ADDENDUM NO. ONE (1)
ILM TERMINAL IMPROVEMENTS
CONTRACT 3

Date: July 12, 2019

RE: ILM Terminal Improvements Contract 3

From: The Wilson Group
PO Box 5510
Charlotte, NC 28299

A1-112

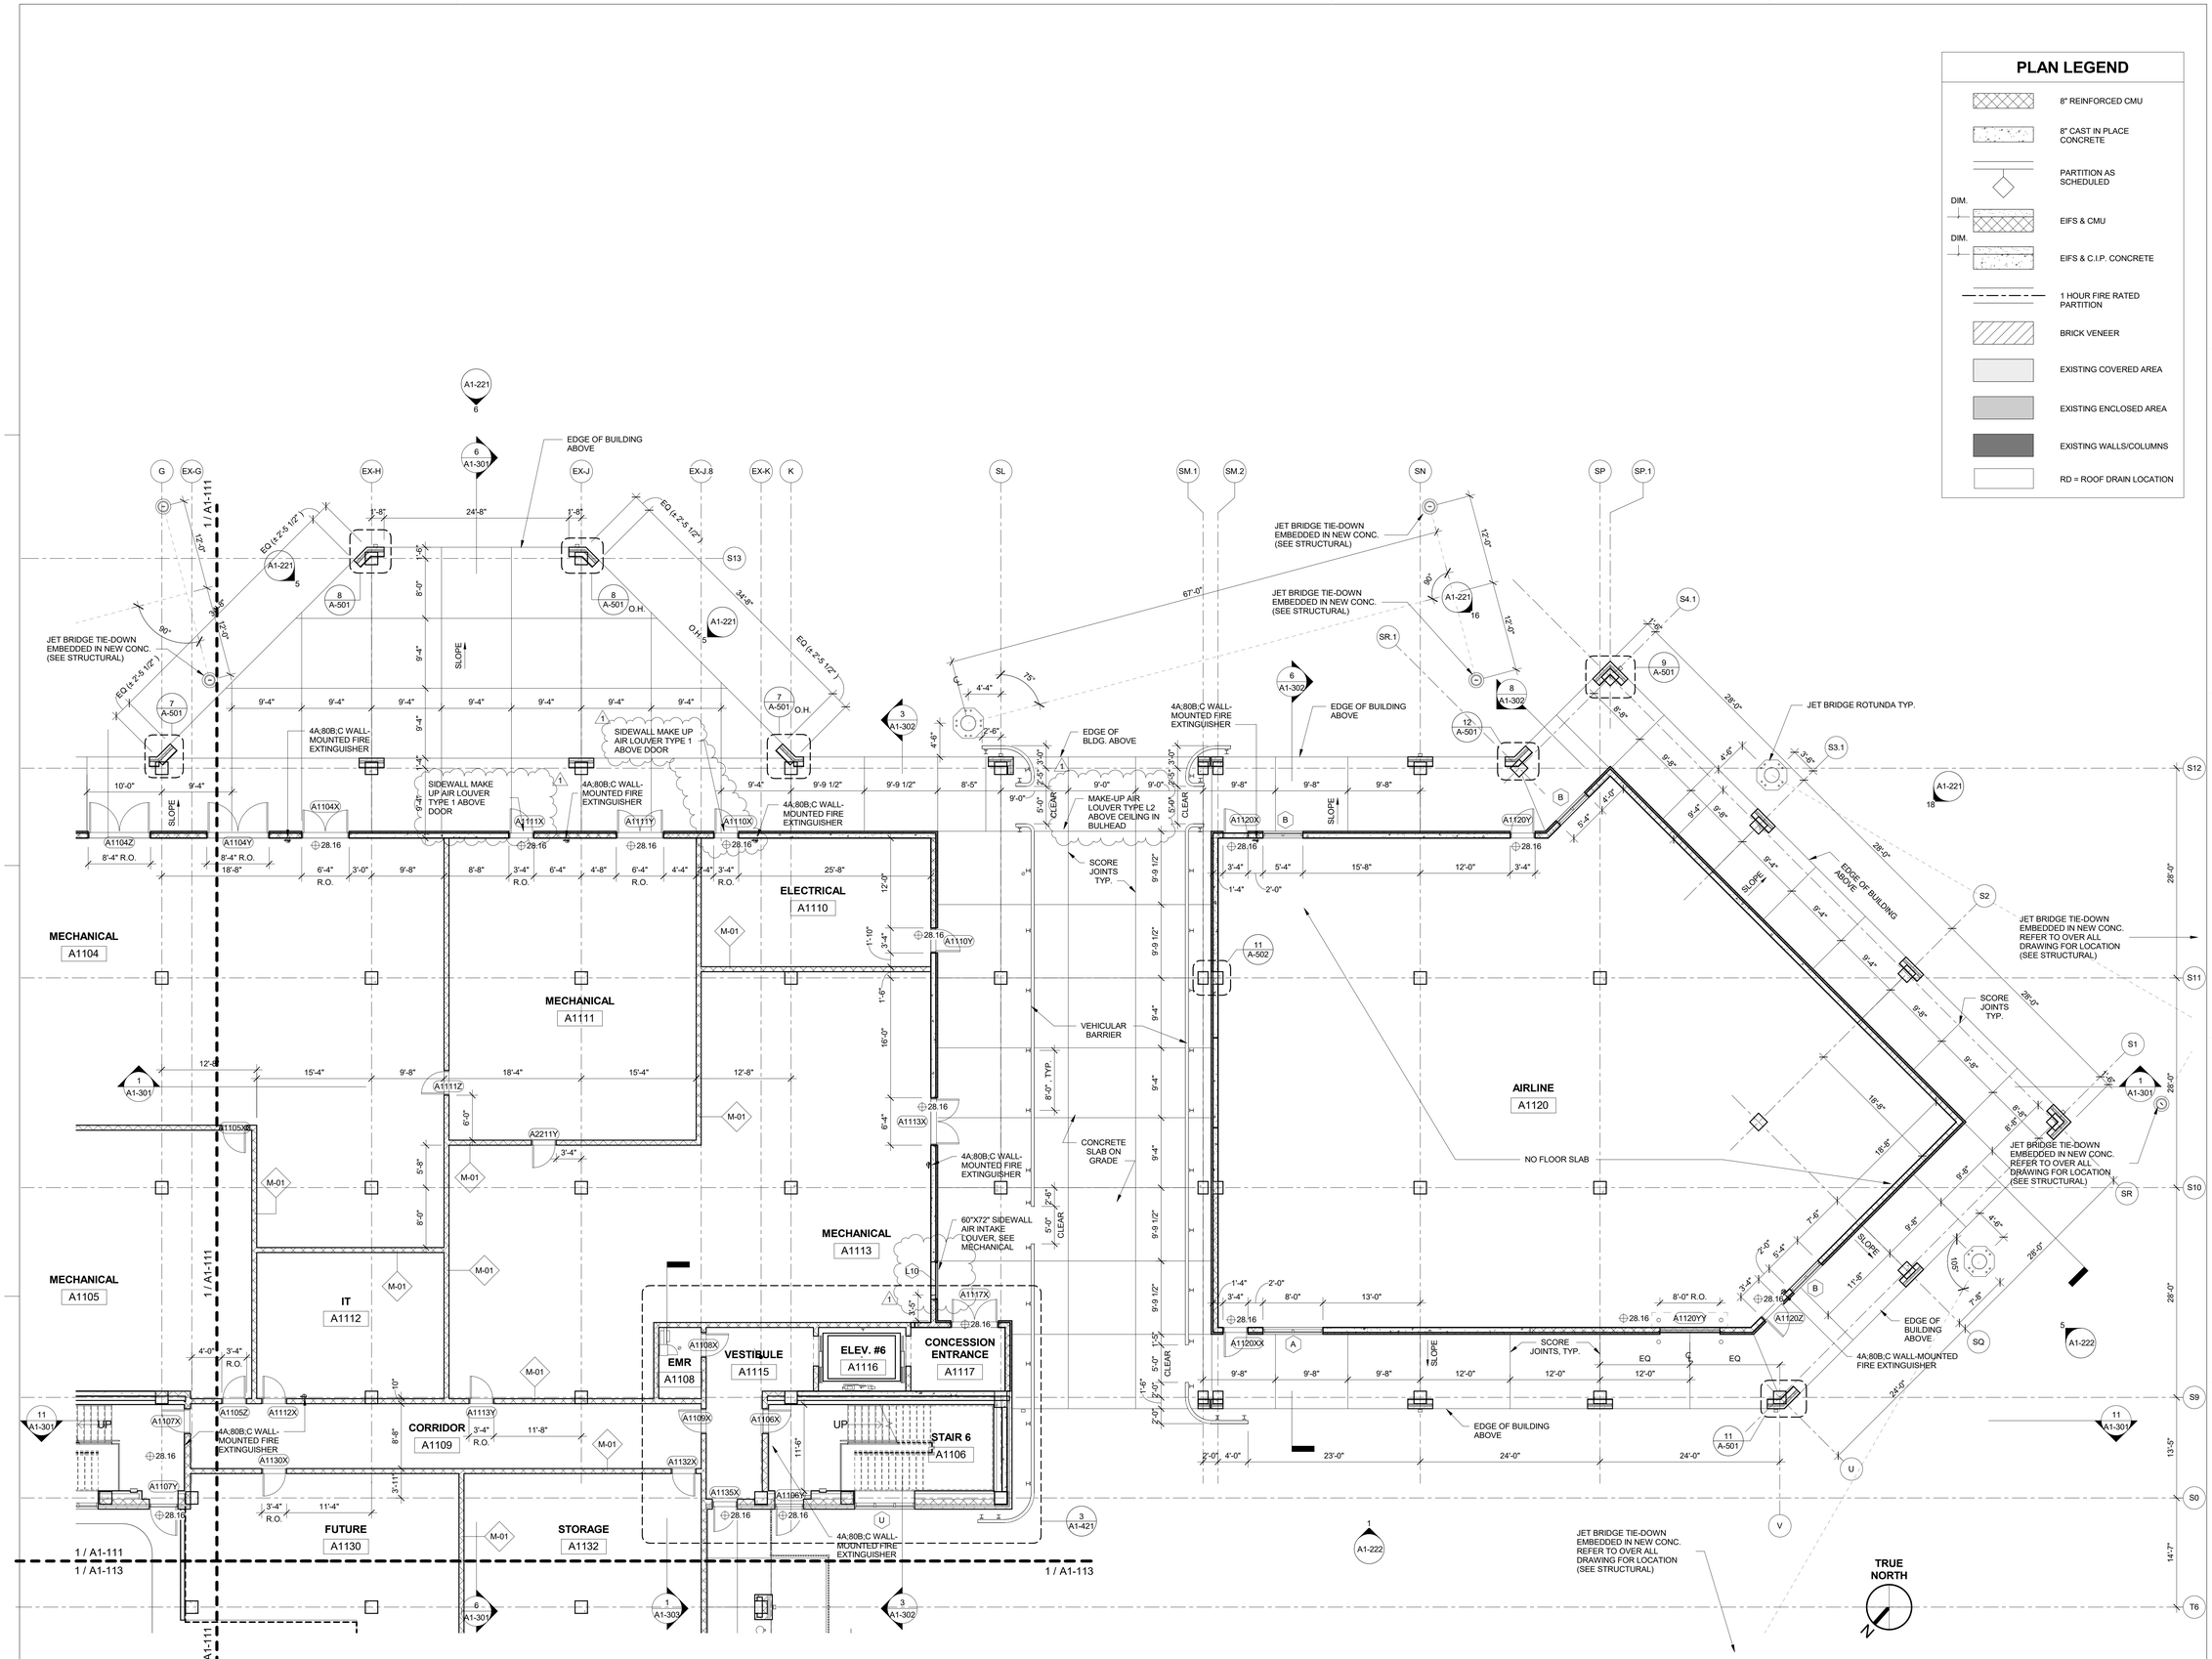
4. QUESTION: Where is the vehicular barrier detail shown on A1-112?
ANSWER: See revised S-302 sheet included with this Addendum.

A1-221

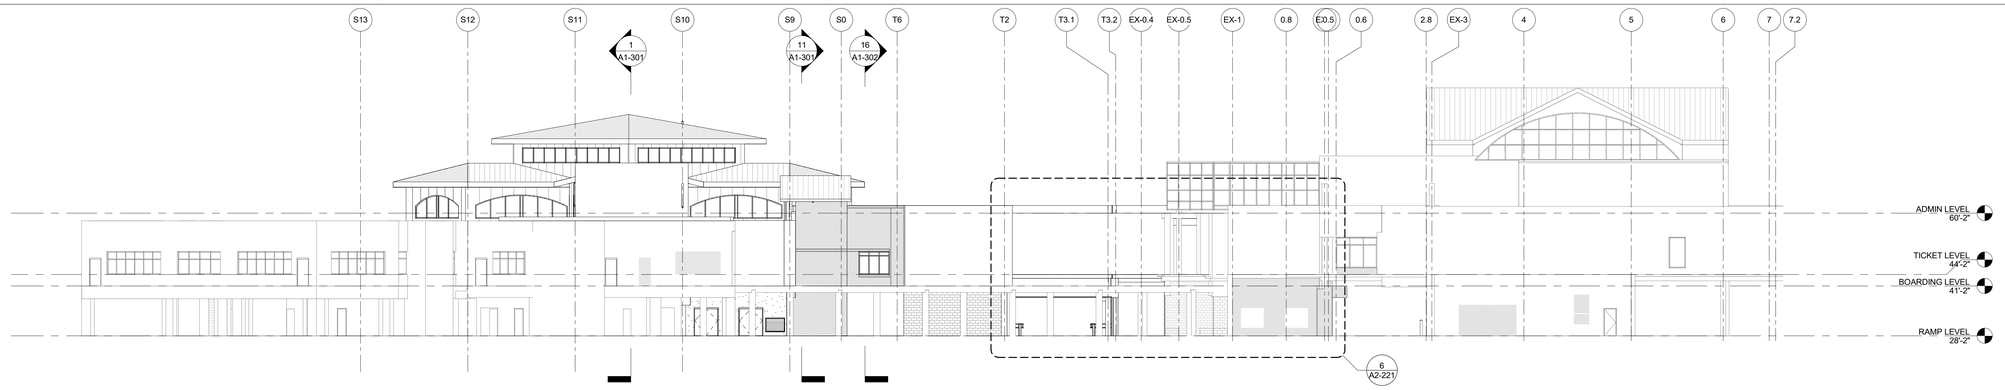
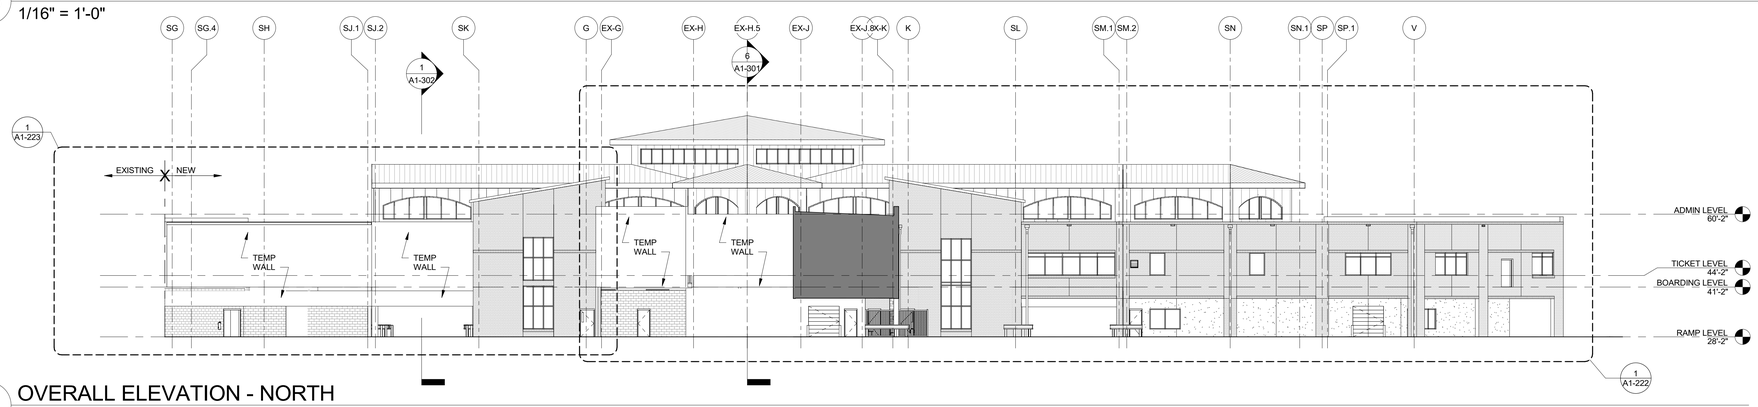
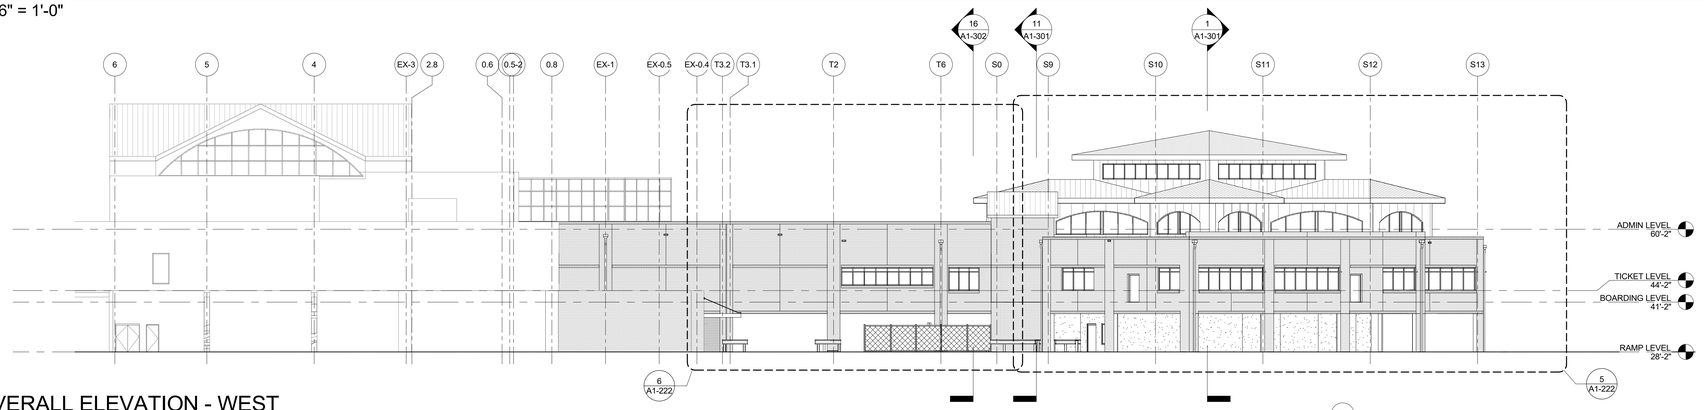
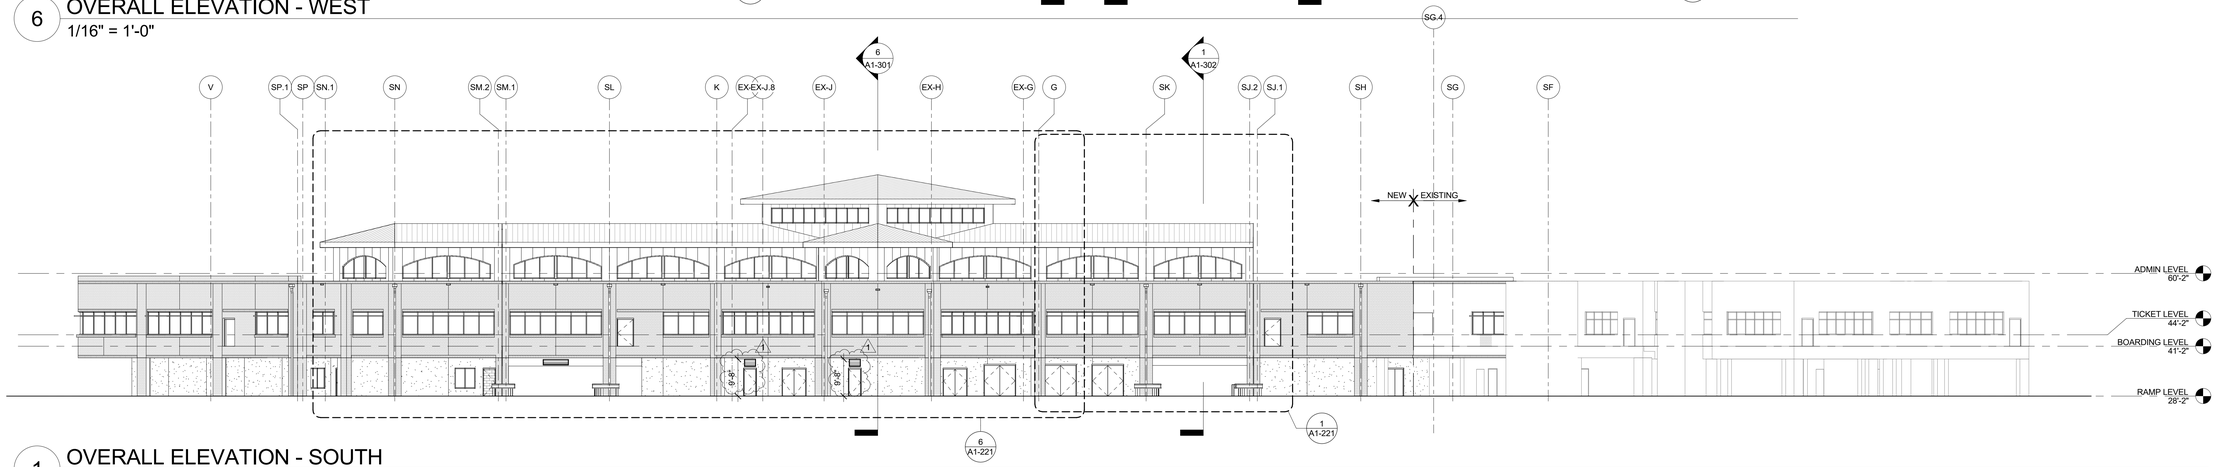
kk. A1-225 – SCHEDULE 1 ENLARGED ELEVATIONS (AD-01). *Note: Showing louvers.*
ll. A1-251 – SCHEDULE 1 INTERIOR ELEVATIONS (AD-01). *Note: Showing TVs & removed data from gate signage.*
mm. A1-252 – SCHEDULE 1 INTERIOR ELEVATIONS (AD-01). *Note: Showing TVs & removed data from gate signage.*
nn. A1-271 – SCHEDULE 1 ENLARGED INTERIOR ELEVATIONS (AD-01). *Note: Showing elevation at signage section – 2 locations.*
oo. A1-402 – SCHEDULE 1 ENLARGED FLOOR PLANS (AD-01)
pp. A1-404 – SCHEDULE 1 ENLARGED SARA PLAN (AD-01) *Note: changed sand bed to cast-in-place concrete, specified artificial turf, provided section showing fence mounting detail, corrected fence type to PVC-coated chain link type.*
qq. A1-421 – SCHEDULE 1 ENLARGED STAIR PLANS (AD-01) *Note: changed fire extinguishers to all be semi-recessed type in cabinet.*
rr. A2-111 – SCHEDULE 2 RAMP LEVEL FLOOR PLAN ZONE 1 (AD-01). *Note: Showing louvers.*

A1-223

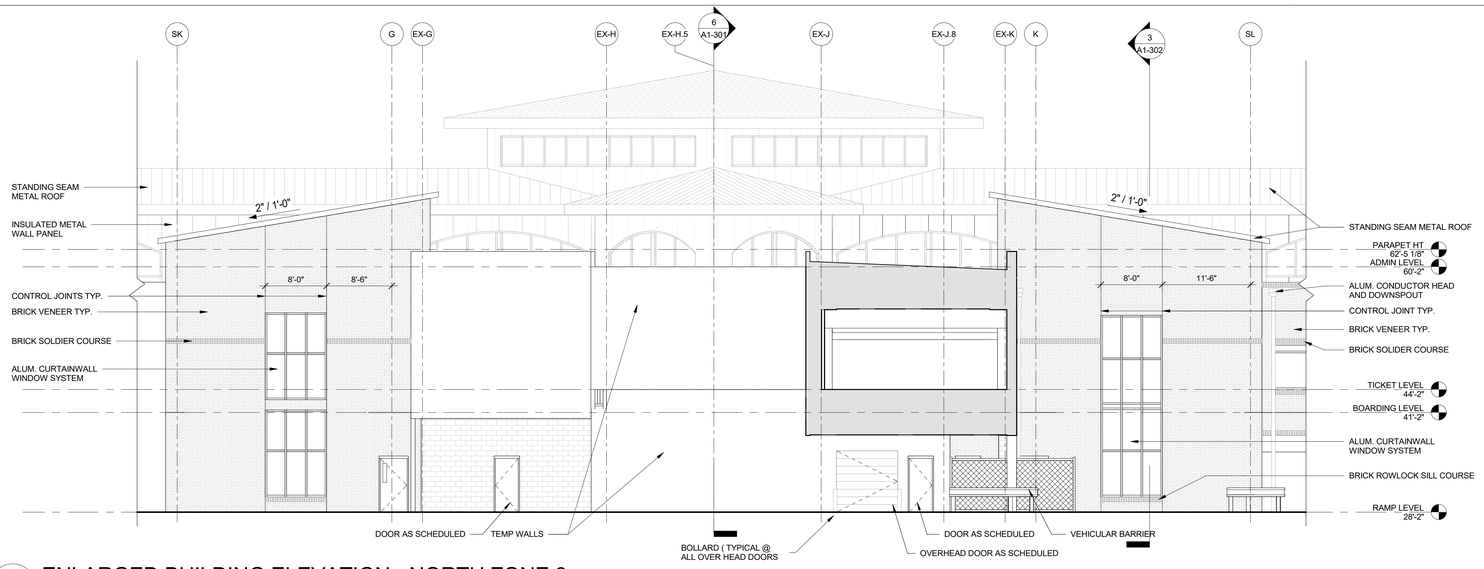
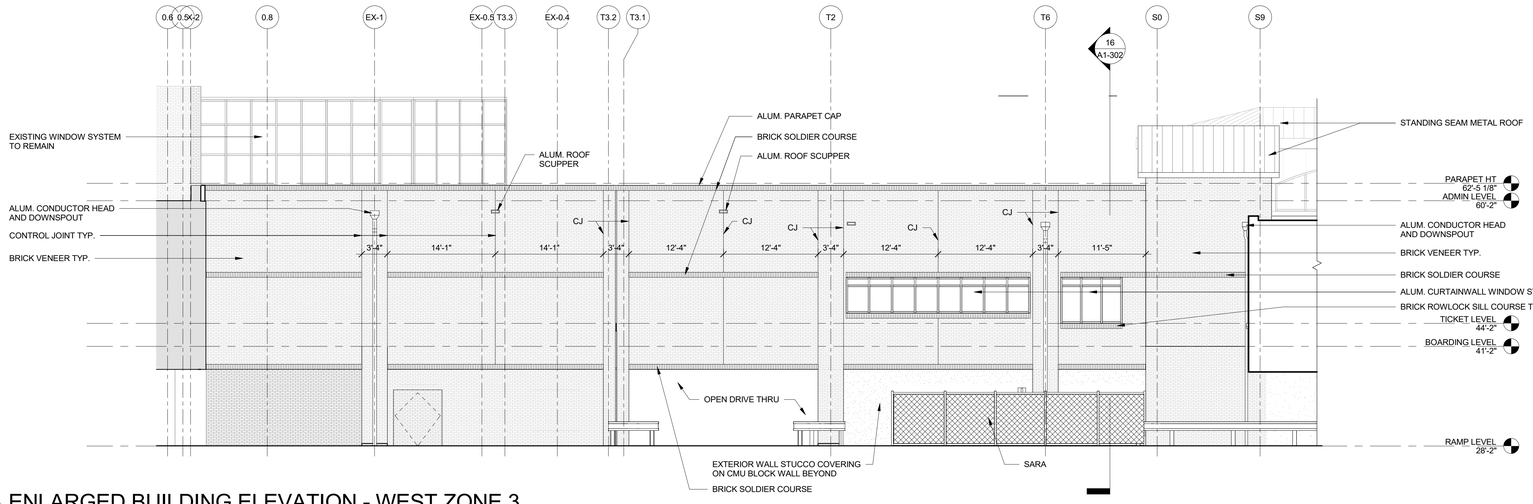
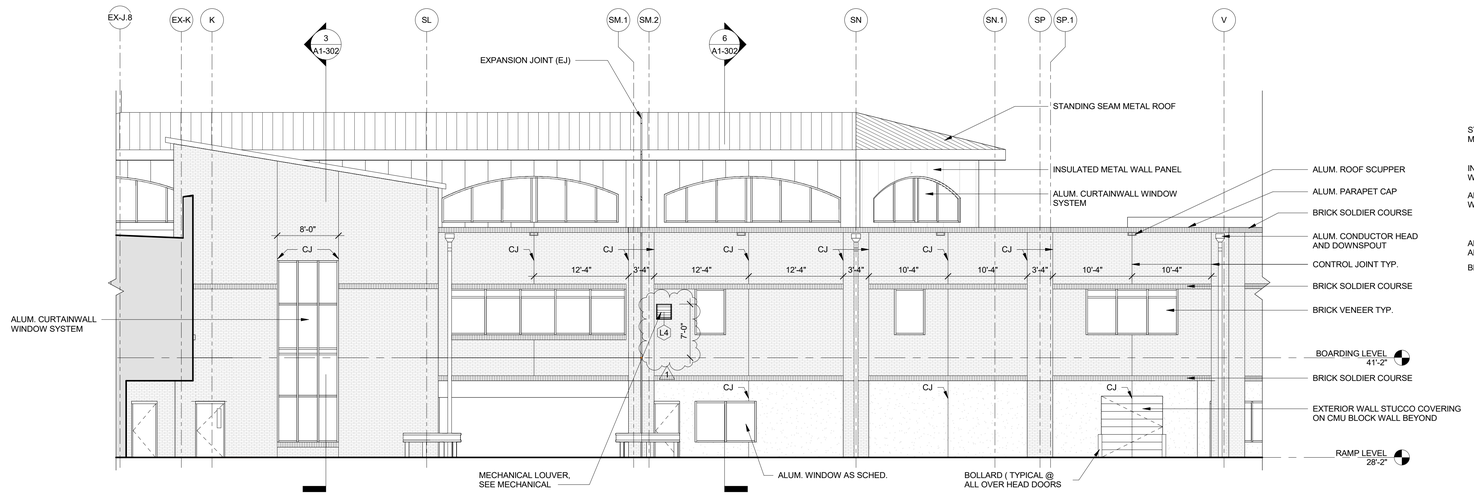
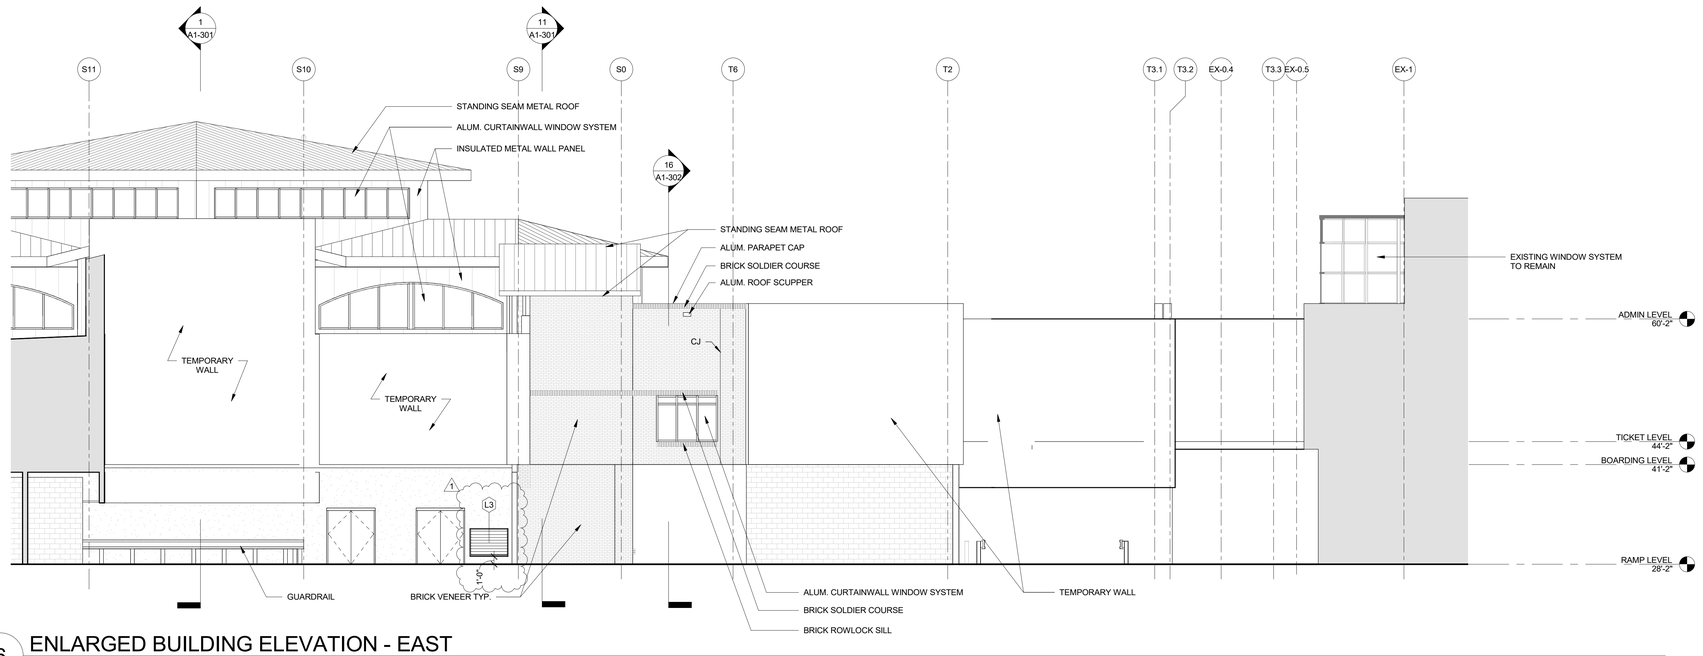
w. S-511 – FLOOR SECTIONS (AD-01)
x. S-512 – FLOOR SECTIONS (AD-01)
y. S-521 – ROOF SECTIONS (AD-01)
z. S-522 – ROOF SECTIONS (AD-01)
aa. S-523 – ROOF SECTIONS (AD-01)
bb. S-524 – ROOF SECTIONS (AD-01)
cc. A1-111 – SCHEDULE 1 – RAMP LEVEL FLOOR PLAN ZONE 1 (AD-01). *Note: Scheduled louver locations identified on plans.*
dd. A1-112 – SCHEDULE 1 – RAMP LEVEL FLOOR PLAN ZONE 2 (AD-01). *Note: Scheduled louver locations identified on plans.*
ee. A1-122 – SCHEDULE 1 BOARDING LEVEL FLOOR PLAN ZONE 2 (AD-01). *Note: Scheduled louver locations identified on plans.*
ff. A1-143 – SCHEDULE 1 ROOF LEVEL FLOOR PLAN ZONE 3 (AD-01). *Note: All roof insulation tapered where noted.*
gg. A1-201 – SCHEDULE 1 EXTERIOR ELEVATIONS (AD-01). *Note: Showing louvers.*
hh. A1-221 – SCHEDULE 1 ENLARGED ELEVATIONS (AD-01). *Note: Showing louvers.*
ii. A1-222 – SCHEDULE 1 ENLARGED ELEVATIONS (AD-01). *Note: Showing louvers.*
jj. A1-223 – SCHEDULE 1 ENLARGED ELEVATIONS (AD-01). *Note: Showing louvers.*
